CONNECTICUT SITING COUNCIL

RE: **DOCKET NO. 508** – The United Illuminating Company (UI) Certificate of Environmental Compatibility and Public Need for the Milvon to West River Railroad Transmission Line 115-kV Rebuild Project that consists of the relocation and rebuild of its existing 115-kilovolt (kV) electric transmission lines from the railroad catenary structures to new steel monopole structures and related modifications to facilitate interconnection of the rebuilt 115-kV electric transmission lines at UI's existing Milvon, Woodmont, Allings Crossing, Elmwest and West River substations along approximately 9.5 miles of the Connecticut Department of Transportation's Metro-North Railroad corridor traversing the municipalities of Milford, Orange, West Haven and New Haven, Connecticut. **Partial Development and Management Plan I Revision.**

Re: Docket No. 508 - The United Illuminating Company Application for a Certificate of Environmental Compatibility and Public Need for the Milvon to West River Railroad Transmission Line 115-kV Rebuild Project - Request for Modification to Structure Locations Near West River Substation

CT DOT CORRIDOR/PROJECT WORK AREA DESCRIPTION

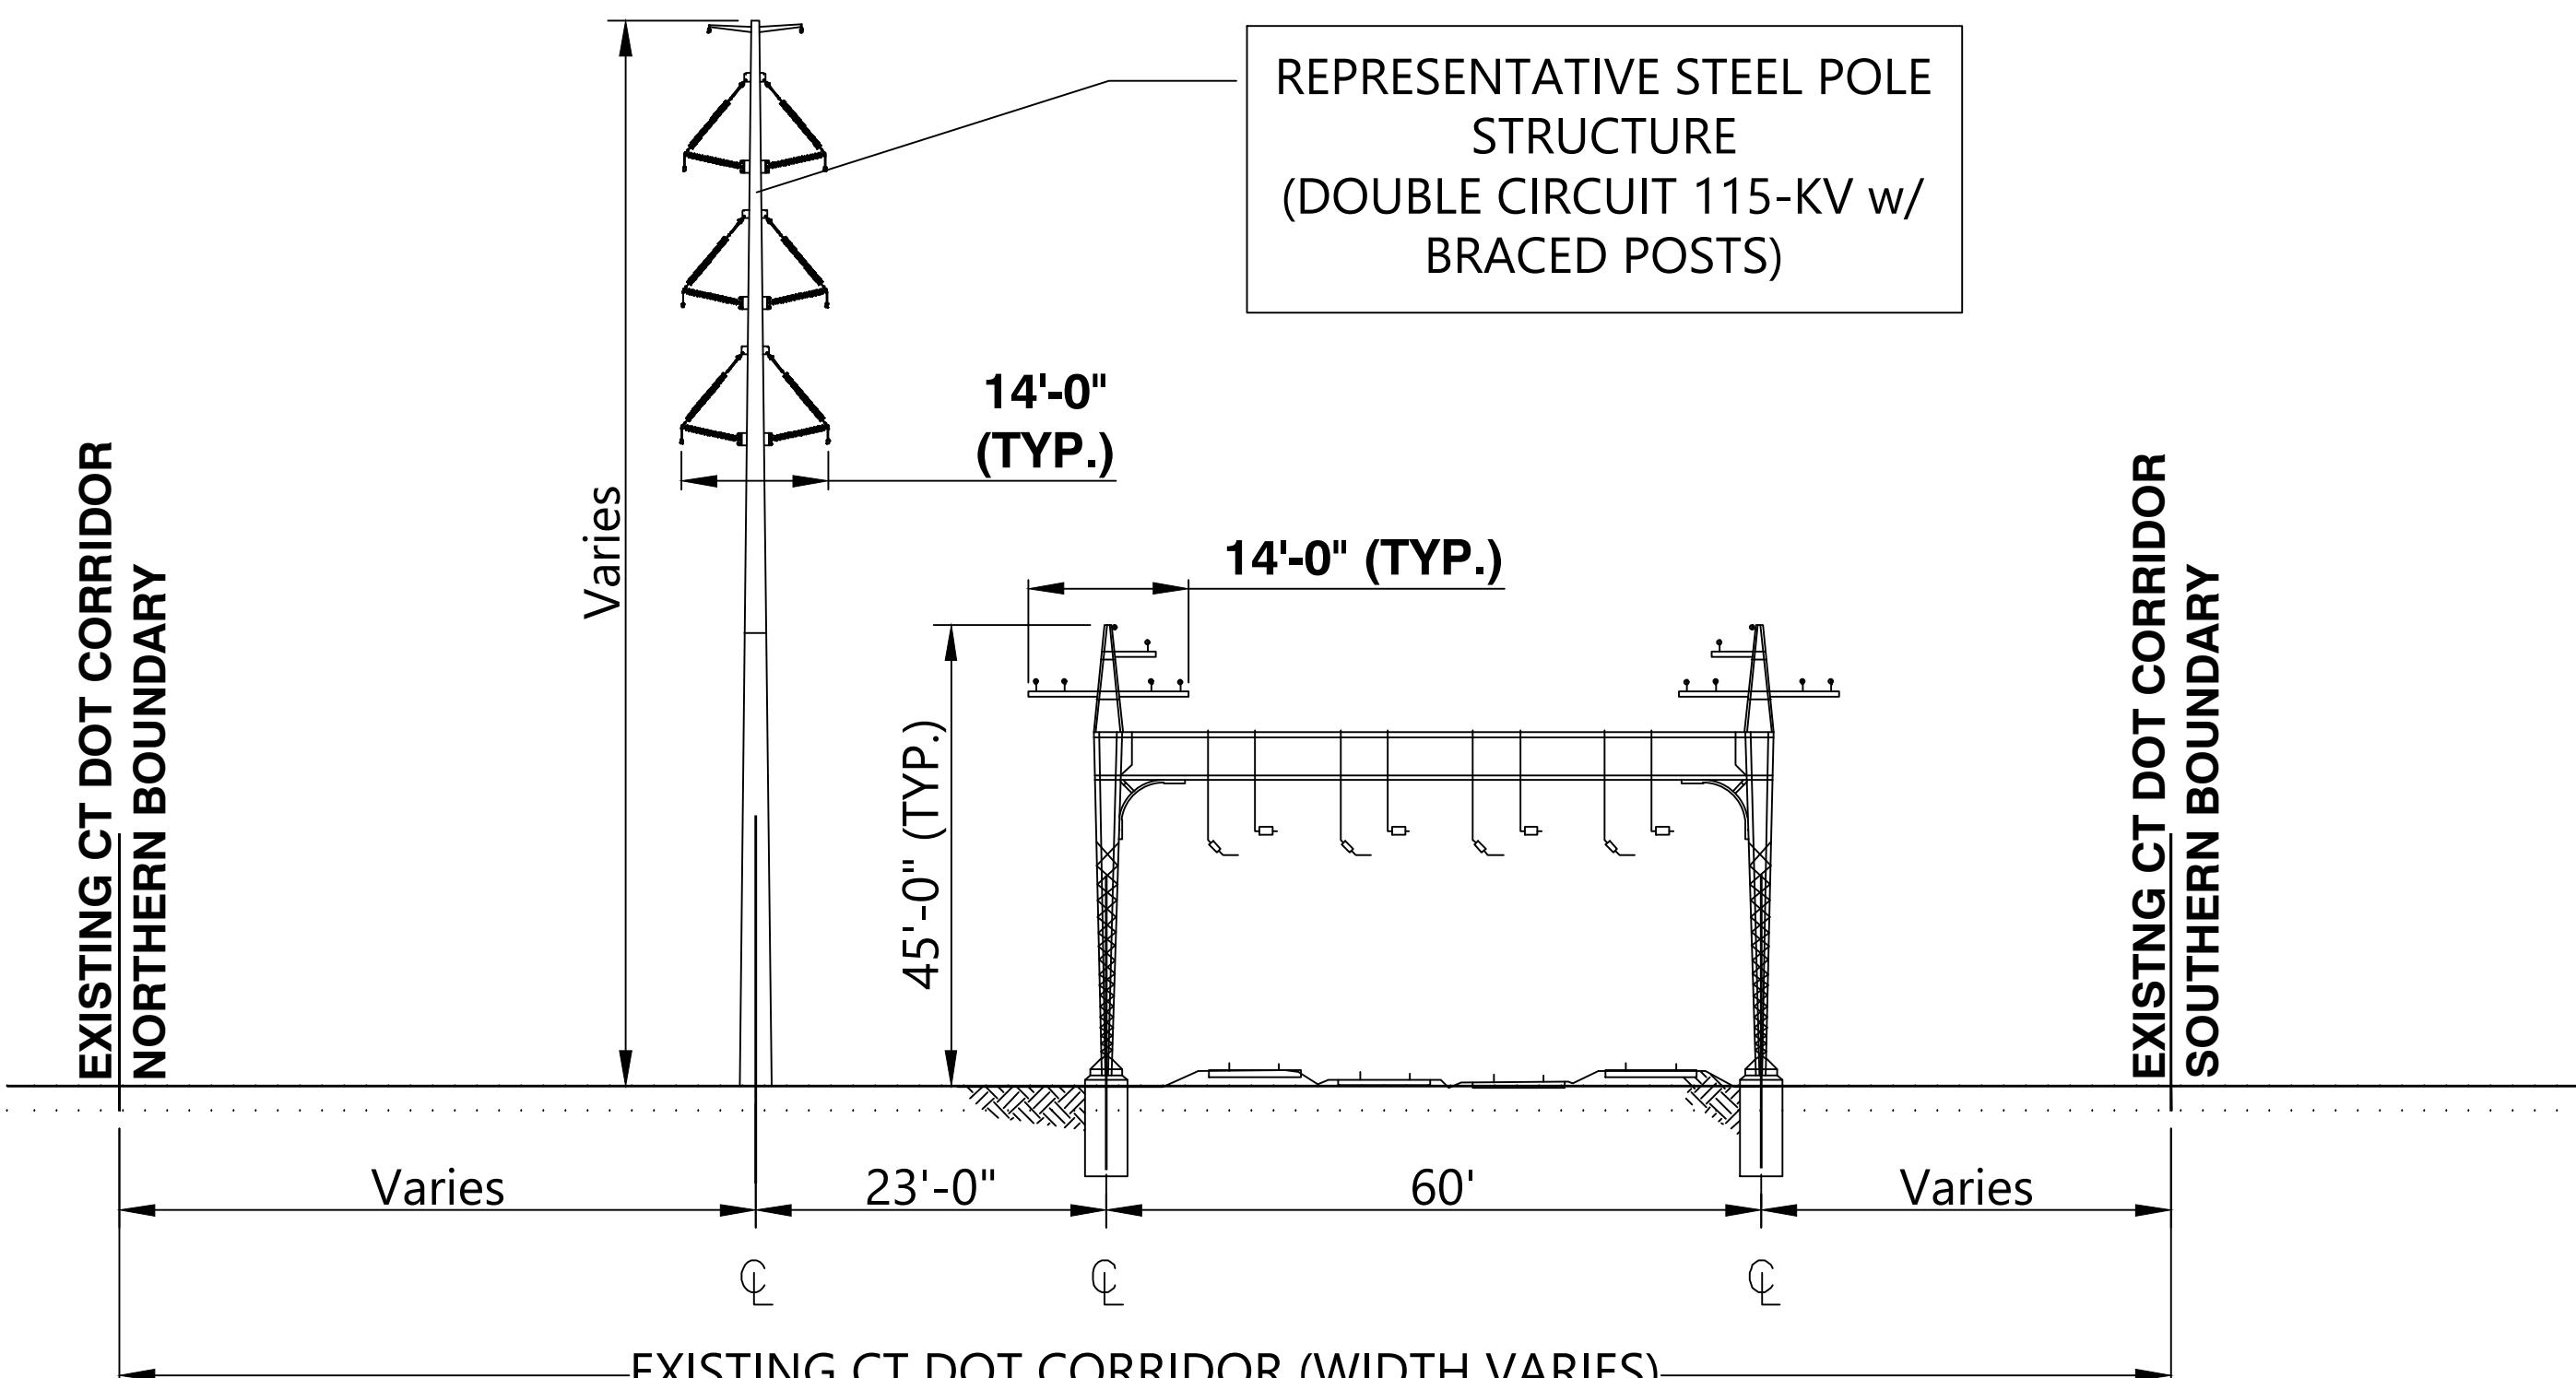
- a) Install a 95-foot deadend Structure P1034N in lieu of a 100-foot tangent structure, at the same location;
- b) Install a 125-foot tangent Structure P1035N in lieu of a similar 95-foot structure, approximately 20 feet in a traverse (northerly) direction and 52 feet in a longitudinal (easterly) direction of the original location;
- c) Eliminate Structure P1036N;
- d) Install a 120-foot deadend Structure P1037N in lieu of a similar 95-foot structure, approximately 47 feet in a traverse (northerly) direction and 33 feet in a longitudinal (easterly) direction of the original location; and
- e) Install a 125-foot tangent Structure P1038N in lieu of similar 125-foot structure, approximately 35 feet in a longitudinal (easterly) direction of the original location.

The Company received comments from the Connecticut Department of Transportation ("CDOT") on the positioning of transmission poles on CDOT property within CDOT's West Haven rail yard which is located north of the MetroNorth Railroad ("MNR") tracks (see Segment 1 D&M Plan, Volume 2, map sheets 2 and 3).¹ Based on those comments it was necessary for the Company to modify the location of the planned monopoles as follows:

STRUCTURE NO.	STRUCTURE TYPE	CROSS SECTION	HEIGHT (FT)	FOUNDATION
P1033N	TANGENT	XS-12	111	CONCRETE DRILLED PIER
P1034N	DEADEND	XS-13	96	CONCRETE DRILLED PIER
P1035N	TANGENT	XS-12	126	CONCRETE DRILLED PIER
